MFN 13-043-R1

NEDO-33633 Markup

NEDO-33633
Revision 0
DRF Section 0000-0127-6662 R1
February 2011

GEH Methodology for Implementing TSTF-493 Revision 4

Figure 3-2 GEH AFT Implementation []

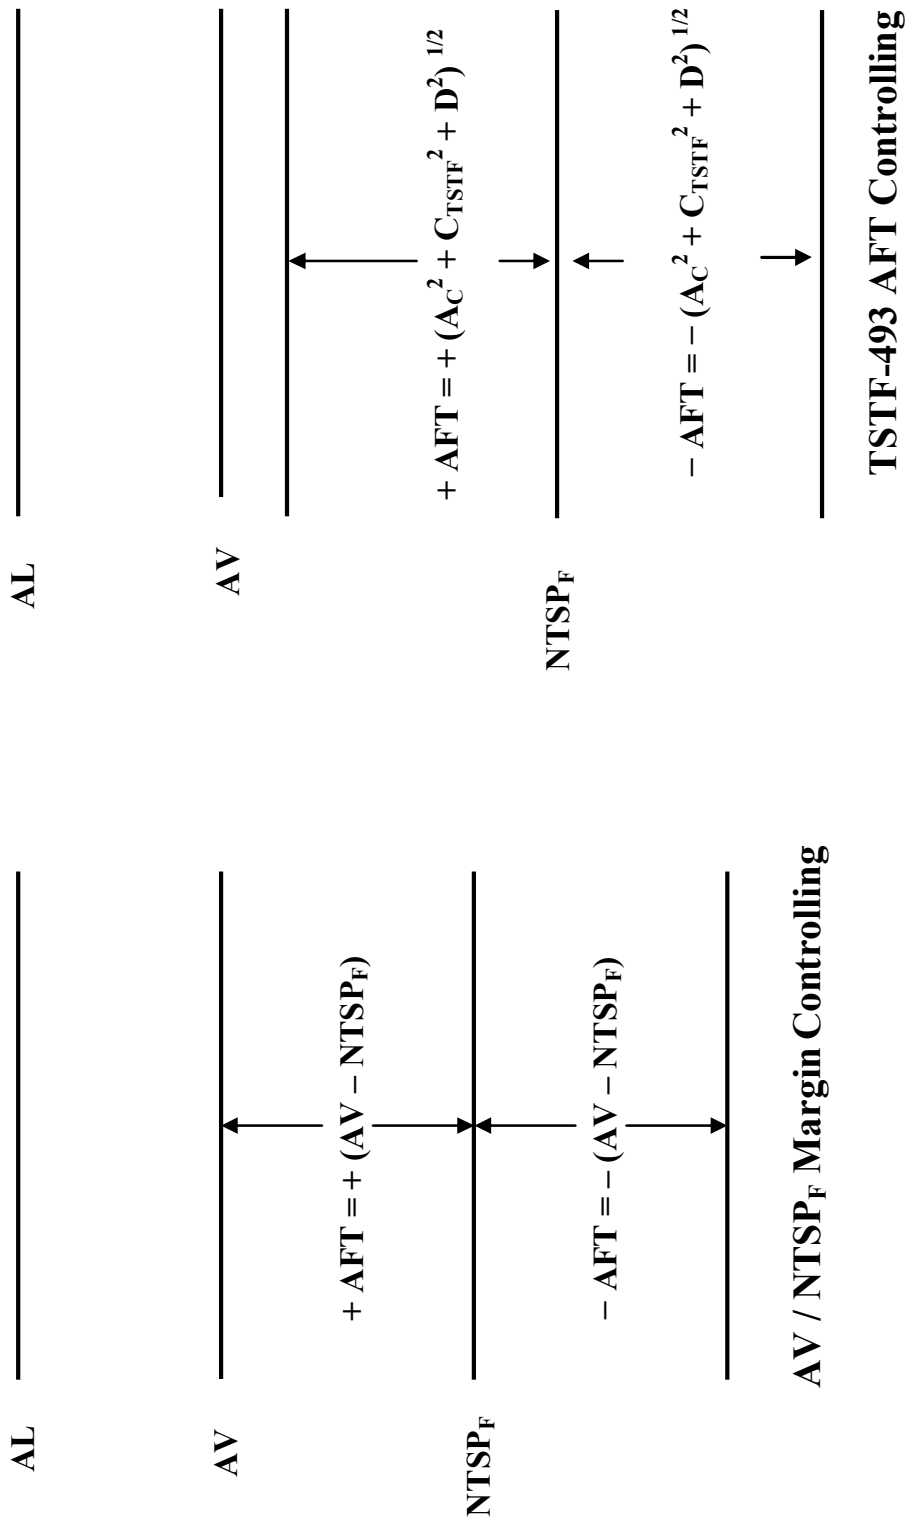
1. AV / NTSP_F Margin Controlling – For GEH Instrument Setpoint Methodology, $|AV - NTSP_F|$ is the LER **Avoidance** Margin. Because of the statistics used in the determination of the LER **Avoidance** Margin, it is expected that this will generally be the controlling case.
2. TSTF-493 Controlling – The AFT calculated using the TSTF-493 guidance may be limiting in certain cases. The most likely example is for a setpoint calculation in which the Licensee has included extra margin (greater than the LER **Avoidance** Margin) between the AV and NTSP_F.
